## Product / Process Change Notification (PCN)

**PCN #:** PCN\_IndMAPI\_20200919

**Affected Series:** WE-MAPI; 744383xxx

**Classification Reflow Profile for SMT components:**

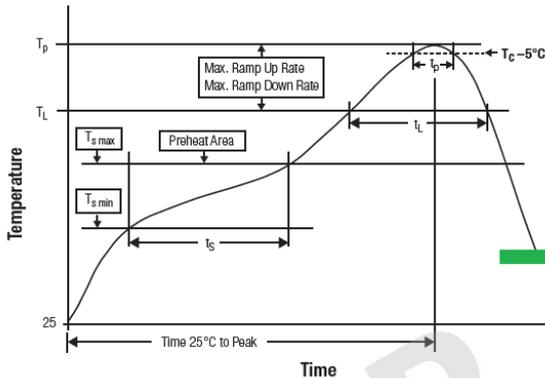
To improve the processability, Würth Elektronik will add a recommendation on the solder paste thickness. This is only a datasheet amendment, there will be no change in form, fit, function, quality or reliability of the product.

**“Make sure that you use the correct thickness of solder paste to avoid an insufficient soldering result. We recommend 100µm solder paste as a reference.”**

Will be implemented under the Classification Soldering Profile and in the Cautions and Warnings.

refer to IPC/JEDEC J-STD-020E  
Make sure that you use the correct thickness of solder paste to avoid an insufficient soldering result. We recommend 100µm solder paste as a reference.
